UNITED STATES PATENT AND TRADEMARK OFFICE

10/591,772

Office Action Summary	Application No. 10/591,772	Applicant(s) CHAPELAIN ET AL.	
	Examiner Thomas Diaz	Art Unit 4171

DETAILED ACTION

Above figures- Hiramitsu et al. steering assembly.

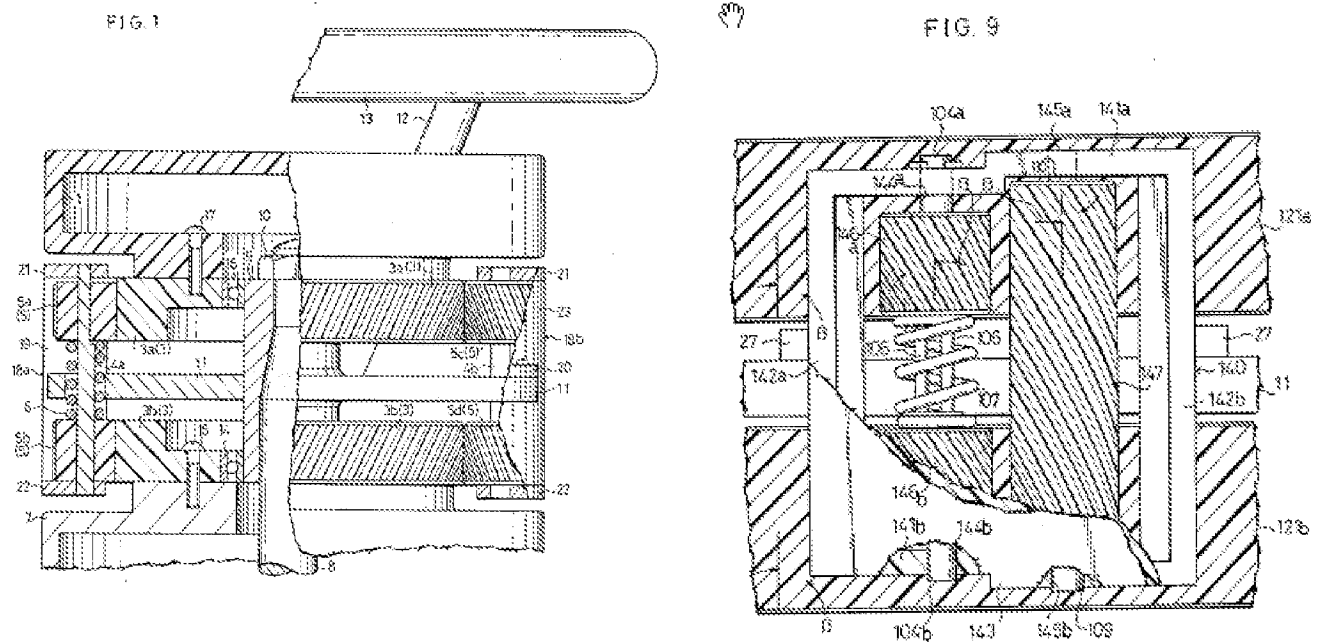
6. Claim 1 is rejected under 35 U.S.C. 102(b) as being anticipated by Hiramitsu et al. (USP 47964482).

Applicant claims a steering wheel (fig.1; Invention directed to a steering wheel, Title) having:

- A first gear element (fig.9, 121a),

- A second gear element (fig.9, 147),
- An anti-backlash gear which is mounted on one of first or second gear elements (fig.9, 146a; Prior art discusses motivation of suppressing backlash in col.2, lines 38-42, and col.13, lines 54-63; Examiner takes the position that this gear is "mounted on" gear 121a although it's not directly on top of it),

- The teeth of the anti-backlash gear configured so as to align substantially with gear on which it's mounted (fig.9, 146a; This is inherent since the gear teeth have to be substantially aligned in order for the device to function.)

- The anti-backlash gear being rotatably biased relative to the gear on which it is mounted towards a position where the teeth of the anti-backlash gear are displaced from the corresponding teeth of the gear element. (fig.9, 146a and 107; the spring biases gear 146a such that the teeth are displaced from the gear on which it is mounted, also explained in col.12, lines 10-21).

Above figures- Laurent et al. steering assembly.

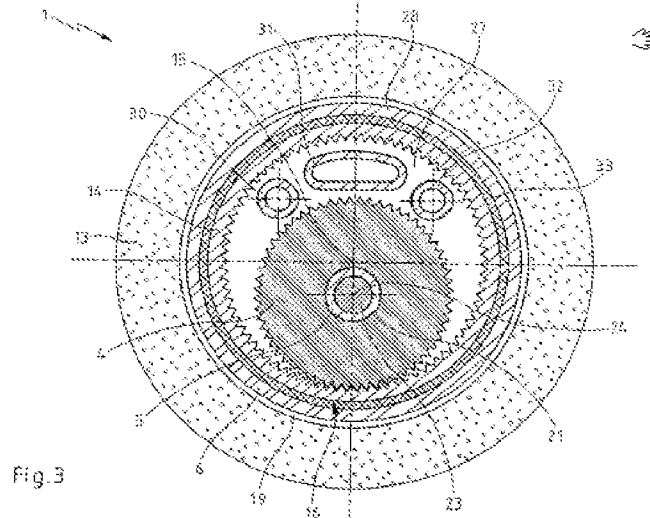
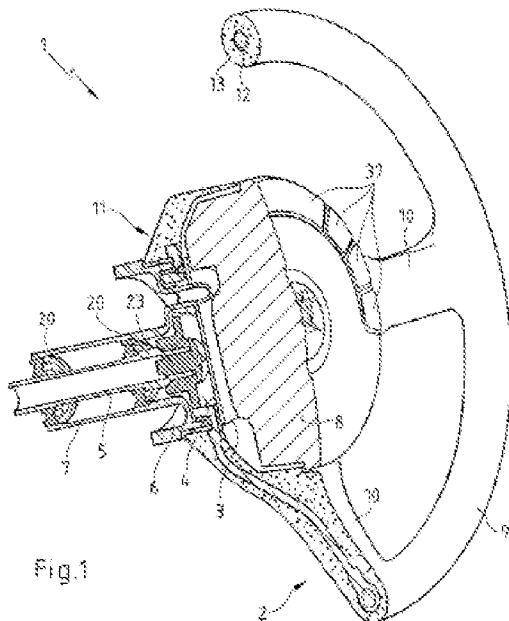
8. Claims 1-3 are rejected under 35 U.S.C. 103(a) as being unpatentable over Laurent et al. (EP1199243A) in view of Wegert (USP 1564160)

Laurent et al. teaches a steering wheel (fig.1, 9) having a first gear element (fig.3, 4; pinion gear) and a second gear element (fig.3, 14; ring gear).

Laurent et al. fails to teach the use of an anti-backlash gear and all the specifics related to the anti-backlash gear claimed through claims 1,2,4-8.

Above figures- Wegert gearing.

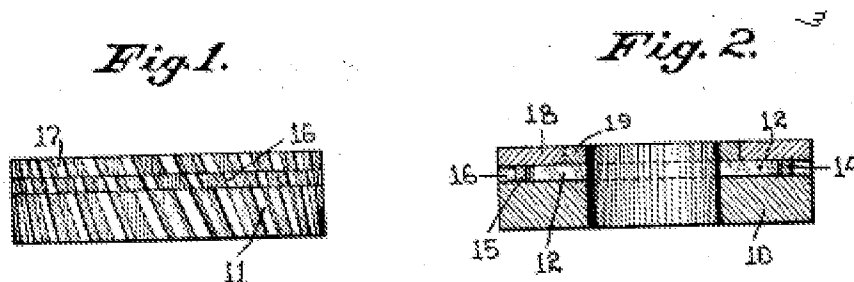
Wegert teaches a silent gear (fig.1) or backlash eliminating gear for preventing noise in the motor of an automobile (col.1, Lines 8-12), having two backlash gears (fig.2, 15 and 18) mounted on a gear element (fig.2, 10). The backlash teeth are substantially aligned with the gear element (seen in fig.1) and they are rotatably biased such that their teeth are displaced from the teeth of the gear element (also seen in fig.1).

Wegert teaches the anti-backlash gears are mounted on said gear element (seen in fig.1).

Wegert is silent towards the gear element being a pinion gear.

Wegert teaches the anti-backlash gears being in form of a plate (seen in fig.1) but fails to teach that they both have apertures.

Wegert also fails to teach the shape of the claimed shape of the spring elements, shape of the apertures and a washer securing the gears together.

Above figures- Maccoul gearing.

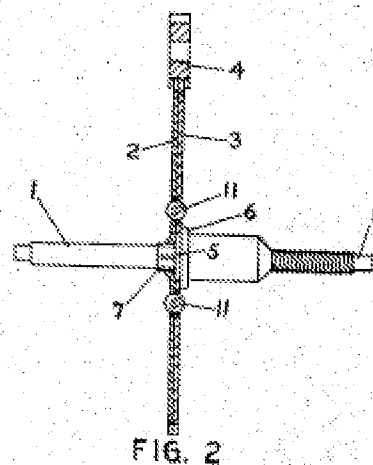
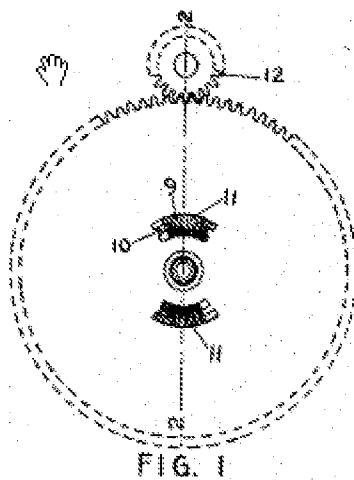
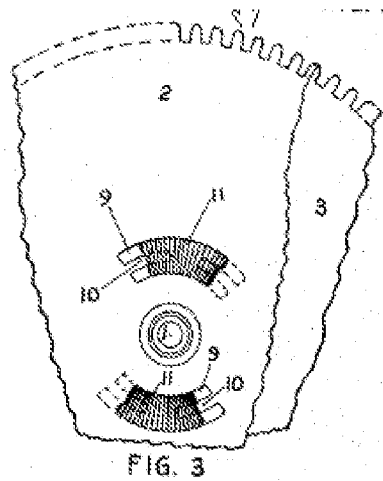
Maccoul teaches a backlash eliminator gearing (fig.1 and fig.2) for eliminating backlash in gear trains (col.1, lines 1-9). The gearing has two backlash gears in the form of plates (seen in fig.1) and each plate having coaligned apertures (fig.1, 9) which hold spring elements (fig.1, 11).

Maccoul teaches “C” shaped spring elements (fig.1, 11), each spring element passing through the apertures and engaging part of the apertures in the plates.

Maccoul teaches the apertures being outwardly directed, bifurcated and with two arcuate slots (fig.3, 9).

Maccoul is silent towards the anti-backlash gears being held in position by a washer. However, Maccoul teaches a shoulder portion (fig.2, 6) which holds the plates.

Above figure- Erickson gearing.

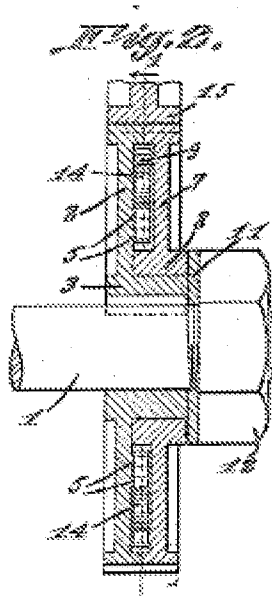
Erickson teaches a washer (fig.2,11) holding a set of anti-backlash gears together.

Therefore, it would be obvious to modify the combination of Wegert and Laurent et al. with the teachings of Maccoul in order to improved backlash elimination because of the aperture and spring arrangement. In addition, it would be obvious to substitute the shoulder taught by Maccoul with a washer taught by Erickson in order to hold the gearing together. It is noted that the shoulder provides the same predictable result as the washer and thus the parts are interchangeable.
